DOCKET 50-255 - LICENSE DPR-20 -
PALISADES PLANT - OVERPRESSURE
PROTECTION SYSTEM

CONSUMERS POWER COMPANY
Docket 50-255
Request for Change to the Technical Specifications
License DPR-20

PALISADES PLANT
PRIMARY COOLANT SYSTEM
OVERPRESSURIZATION SUBSYSTEM DESCRIPTION

FIGURE 2

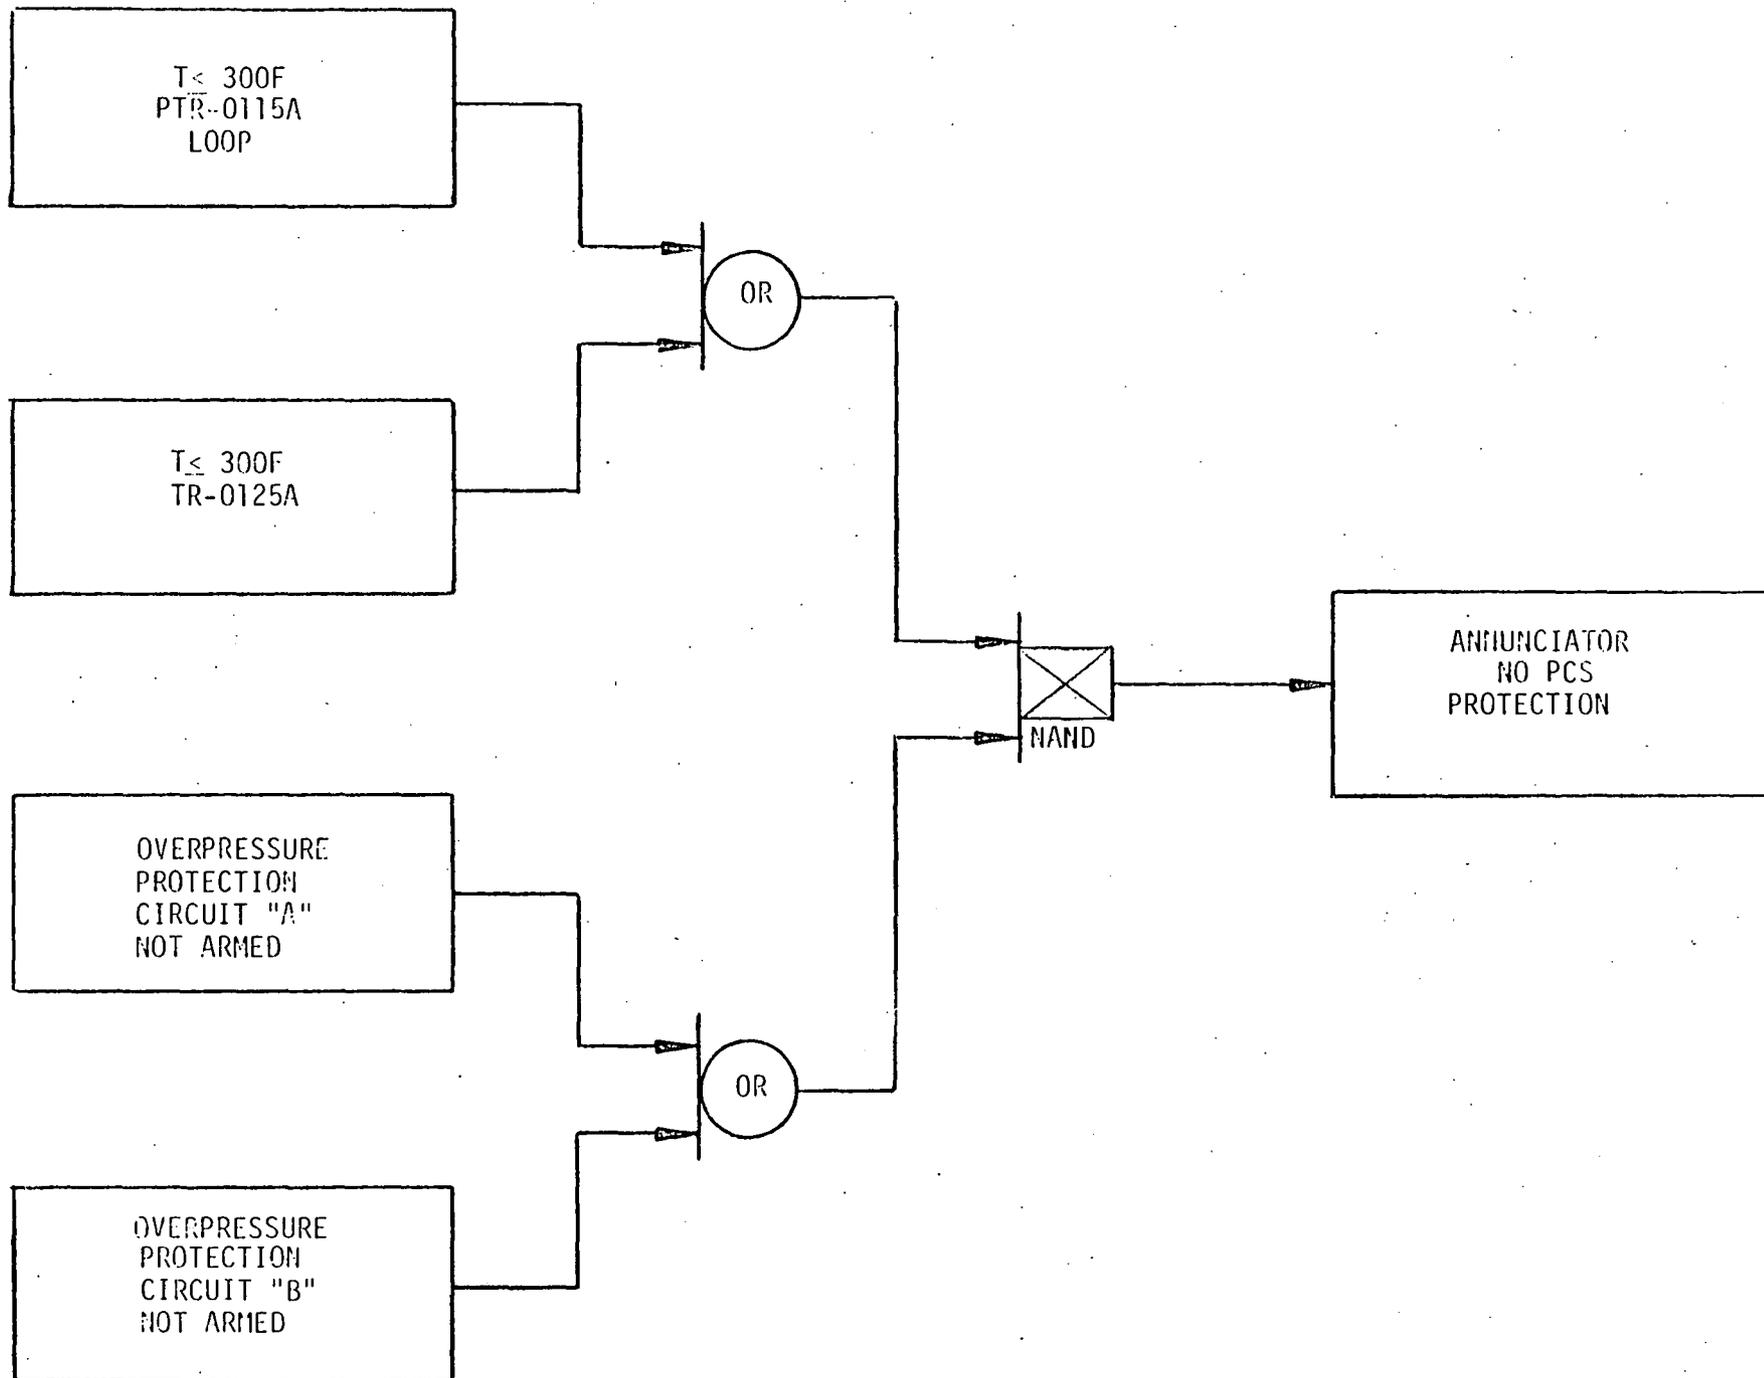
2. Isolation Valve Alarm: The upstream isolation valve from the PORVs must be open for the overpressure protection system to properly function. Some means should be provided to insure proper alignment of the isolation valve during overpressure protection system operation.

Staff Position: The position of the upstream isolation valve should be wired into the overpressure protection alarm so that the alarm will not clear unless the system is enabled and the isolation valve is open.

The overpressure protection system is designed to ensure that the isolation valves MO-1042A and MO-1043A must be open to allow the arming of the system. If, in fact, they are not opened, the "armed" indicating light will not illuminate when the keylock switch is turned to the "on" position and the annunciator window "no PCS protection" will alarm when the PCS temperature decreases below 300°F.

FIGURE 4a

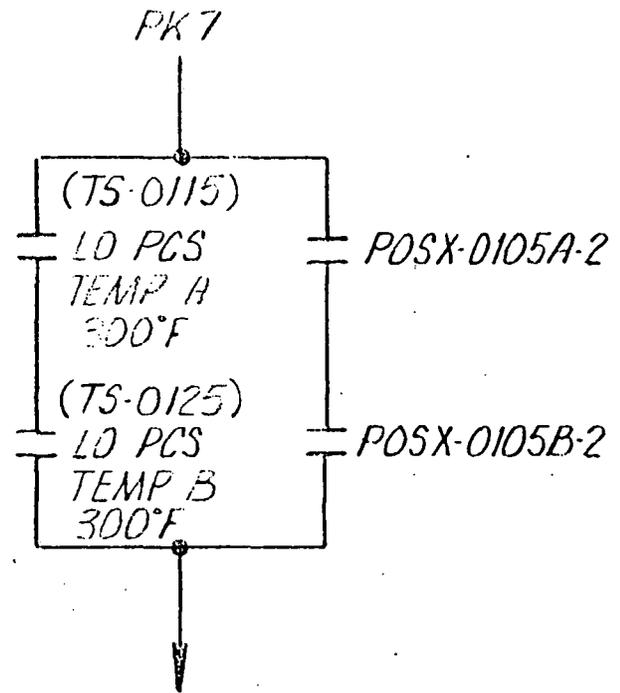
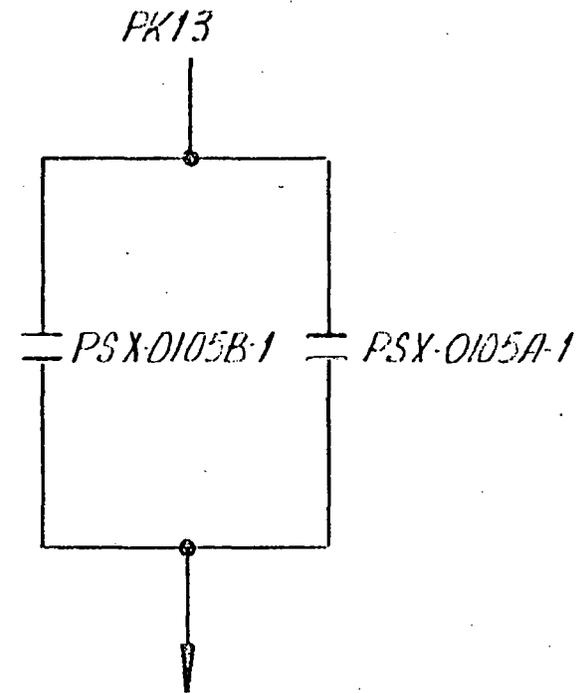
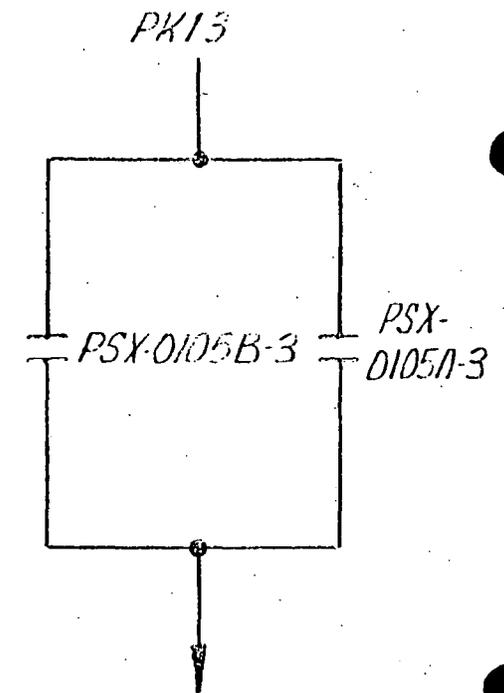
4. Circuit Diagrams: Licensees have not been submitting detailed circuit diagrams with their plant specific reports.

Staff Position: Licensees should submit a detailed diagram of the overpressure protection circuitry with their plant specific reports for review by NRC.

Detailed diagrams, schematics, and system operating description are included in the report "Palisades Plant Primary Coolant System Overpressurization Subsystem Description" and the construction package. This information is an attachment to this letter.
